DEVELOPMENT HEARING OFFICER
SUPPLEMENTAL SUBMITTAL

PROJECT NO. PR-2021-005717

DESCRIPTION: Submittal to address Sketch Plat comments to supplement the preliminary plat application.

RE: Volcano Mesa at The Trails / Tract 2, Unit 2, The Trails
Sketch Plat Comments / Responses – DFT Hearing 08/02/2023
PR-2021-005717
PS-2023-00132 – Sketch Plat
Agenda Item No.: 6

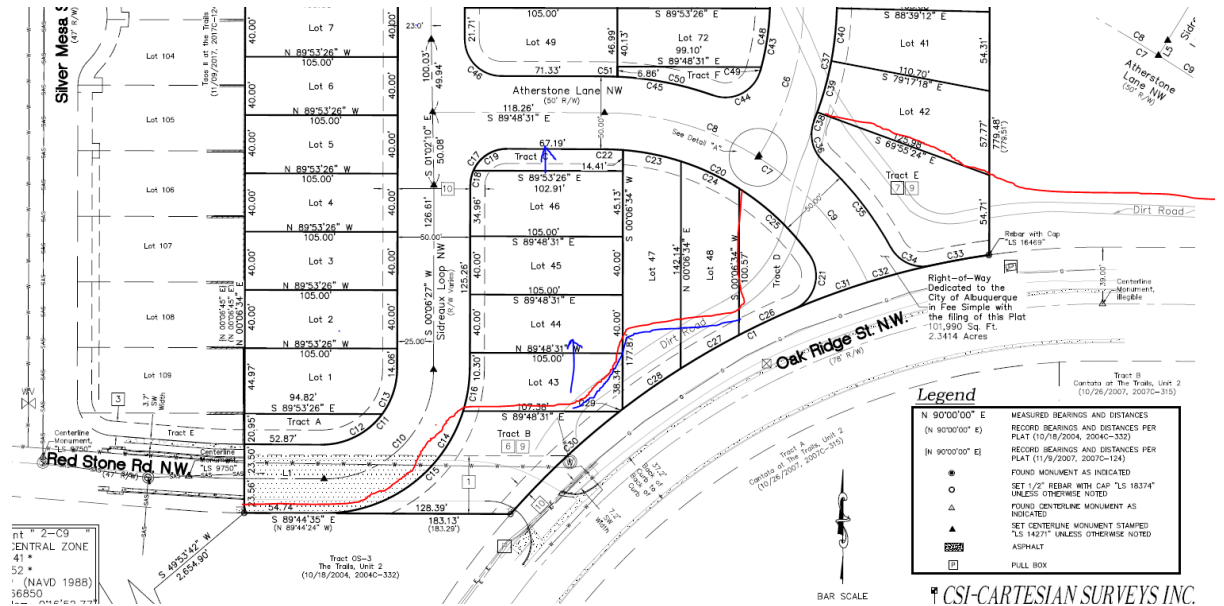
- Recent planning work has identified the value of continuing the east-west linear park and trail system that is well established through the Trails subdivisions to the west. With modifications to only three lots, this subdivision can continue this amenity that enhances the subdivision you are creating and provides east-west connectivity for the community in this area. (The red line below points out the open space that can be part of this system.) The connected open space maintains the natural desert ecosystem through this area. Could lots 43 through 46 be moved north to allow for an open space band along the north side of Oakridge? Could lots 47 and 48 be reduced from their unusually long dimension to provide the connection to Tract D? (The blue lines indicate recommended lot changes.)

RESPEC Response: The issue that DR Horton would face both in shifting Lots 43 – 46 into Tract C and reducing the length of Lots 47 and 48 is two of the lots (43 and 48) would be left with shorter pad depths. Their home buyers, from one community to the next, display a strong preference for single-story homes. They need every inch of the 70' pads constructed on Lots 43 and 48 to accommodate a single-story plan lineup. We feel that a trail system is already in evidence by following the path along Oak Ridge St. to Redstone and its continuation along the drainage ponds/open space to the west that runs to and past Rainbow Blvd. Their development of Tracts B, D, and E are intended to add volume to the landscaped area and walkway without compromising the single-story opportunity.

1 TYPICAL 32' STREET SECTION STA 20+35.08 TO 23+43.61 SIDREAU LOOP AND ATHERSTONE LANE
NOT TO SCALE

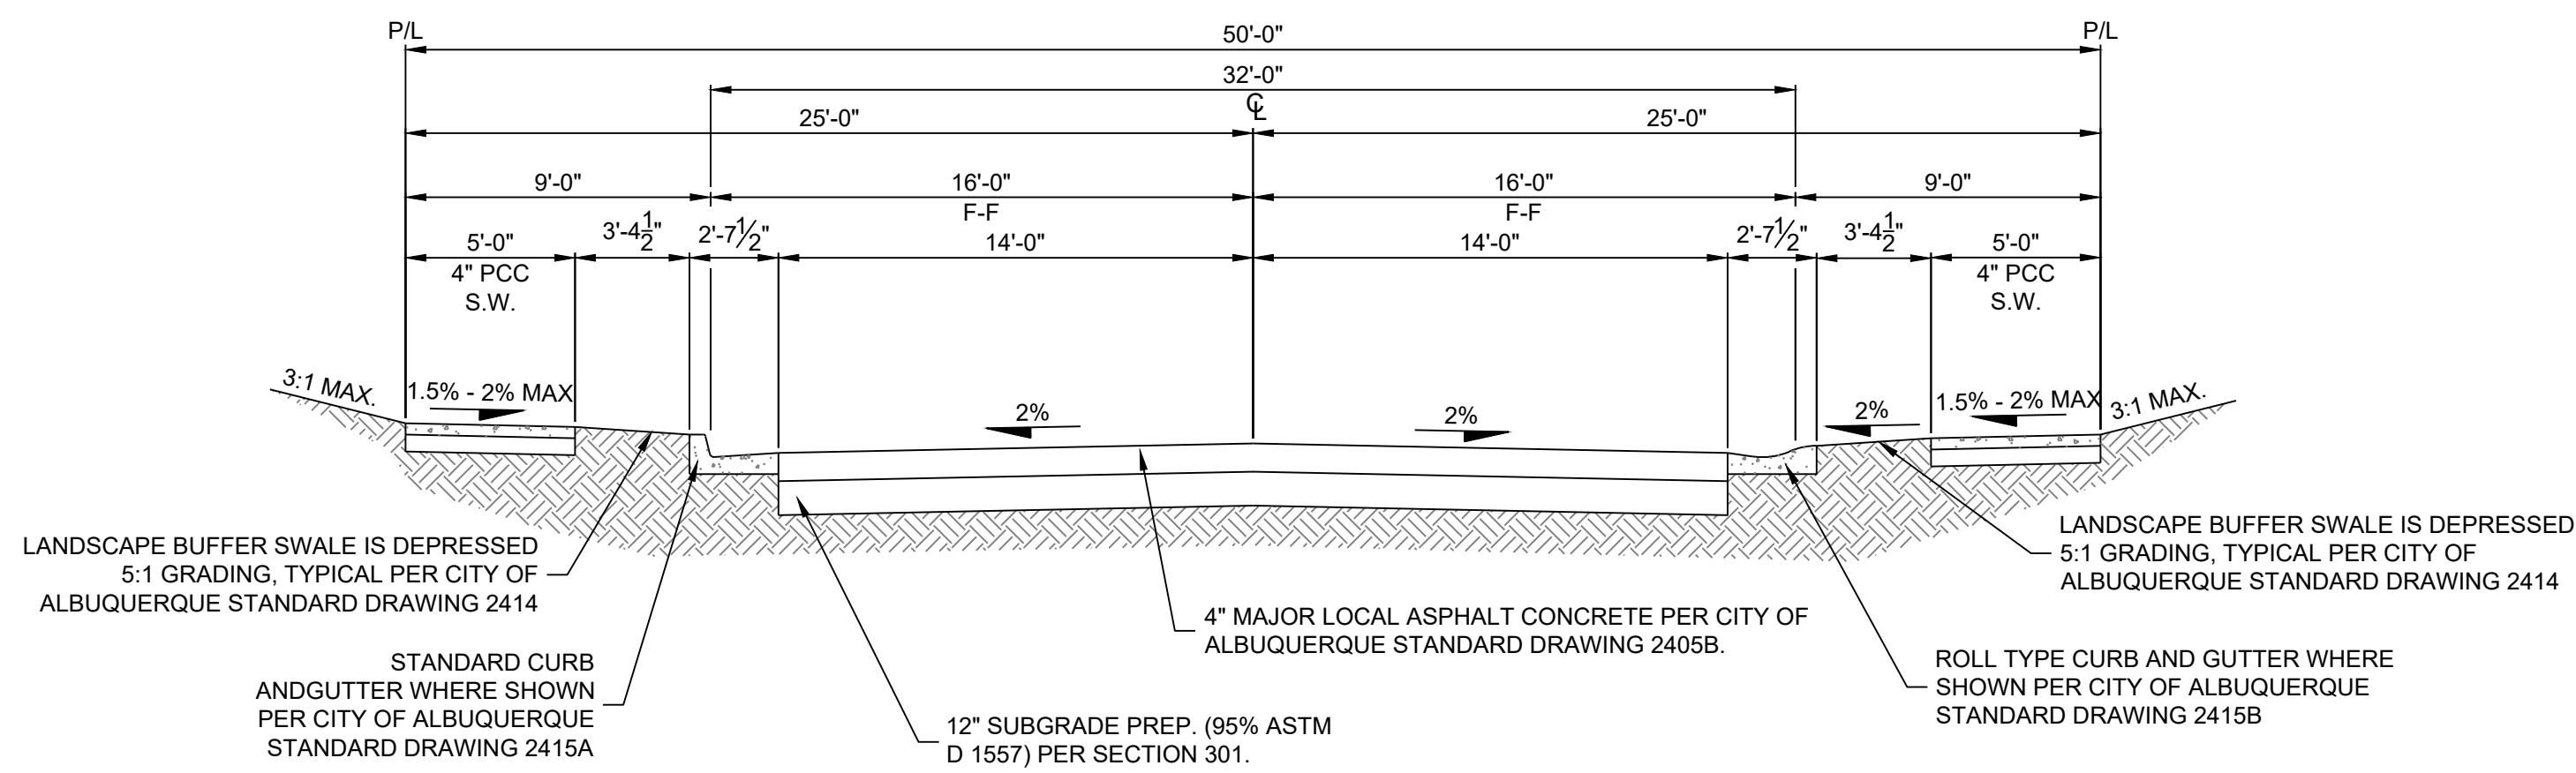
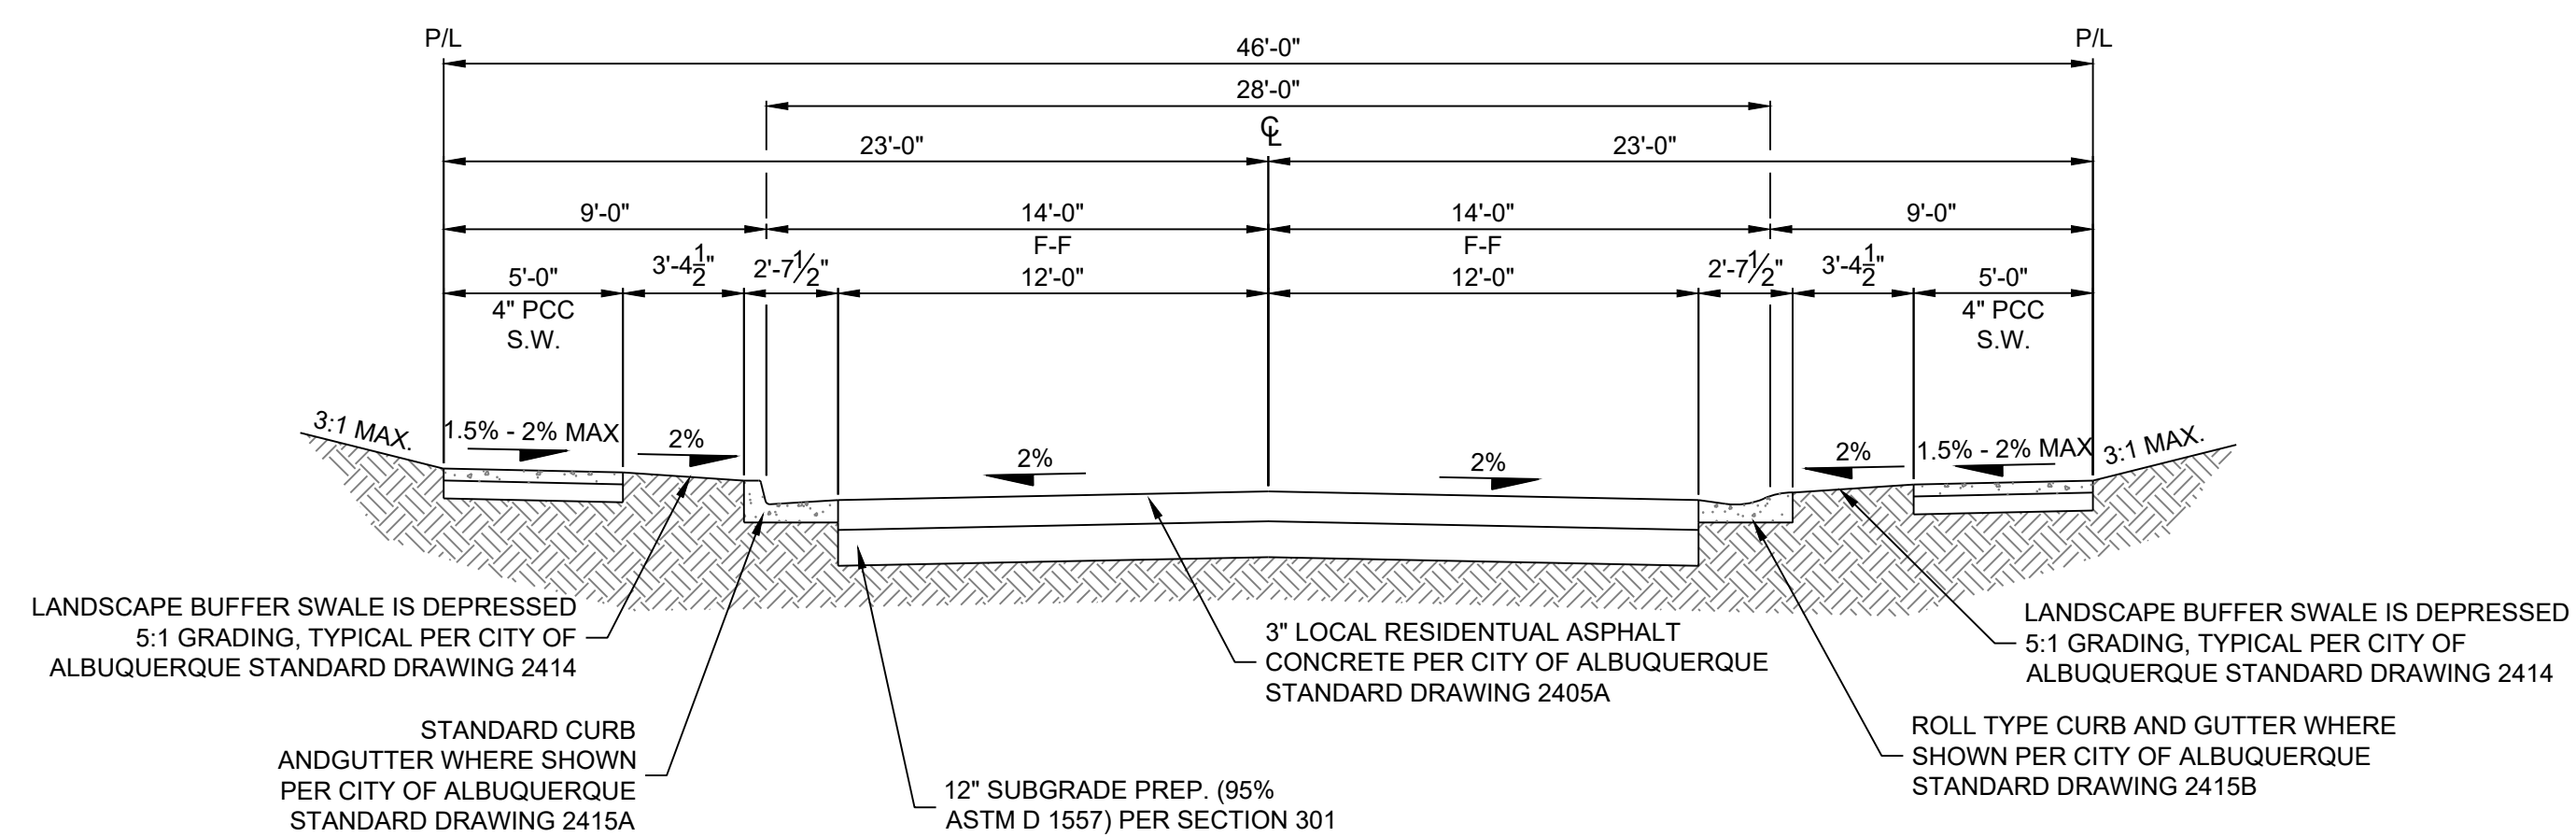
2. Please provide road cross-section for all interior roads. A 5' sidewalk with a 4-6' landscape buffer is required as these are local roads.

RESPEC Response: We provided roadway cross-sections, including landscape buffers, to DRC and which had been approved on April 6, 2023. These streets have been built per these construction plans.
